# Essex Local Access Forum (ELAF) deadline 5 submission (10 May 2023) Interested Party ref 2033138

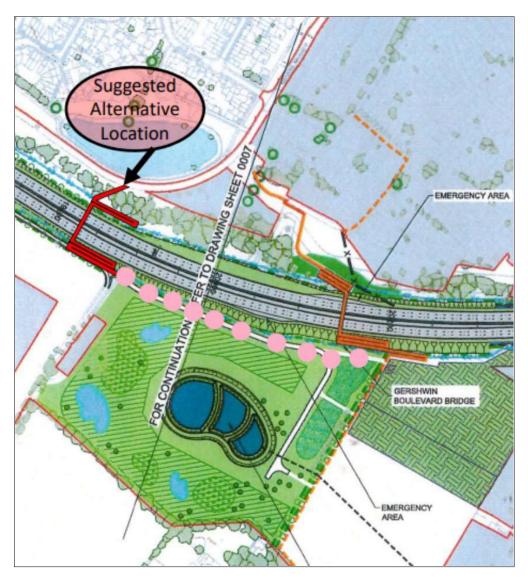
The ELAF proposal to link Witham FP103 [PROW 121-103] with the Whetmead Nature Reserve and Witham FP 101 [PROW 121-101] along the "country" (south) side of the A12 is within National Highways red line boundary and so does not require any additional land take. As stated, it would provide a circular leisure route for the people from Witham linking two A12 crossing points – the re-configured Little Braxted Lane bridge and the existing Witham FP 101 underpass. It would fill a network gap as there are no PROW /WCH routes between Little Braxted Lane and the WhetMead Nature Reserve (open public access) so would meet the NPPF paragraph 100 criteria and ECC's ROWIP.

ECC's support and preference expressed on page 27 of REP4-075 for ELAF's proposal is welcome. The plan from ECC's document REP4-075 page 27 is included below to be read together with ECC's text that to..."create a path south instead, linking footpath 103 with footpath 121, a route that would follow alongside the A12 within the red line boundary (indicated by pink dots in the plan extract below). This would be our preferred outcome. We would be happy for these paths to follow vehicle access tracks / maintenance tracks once the build is complete."
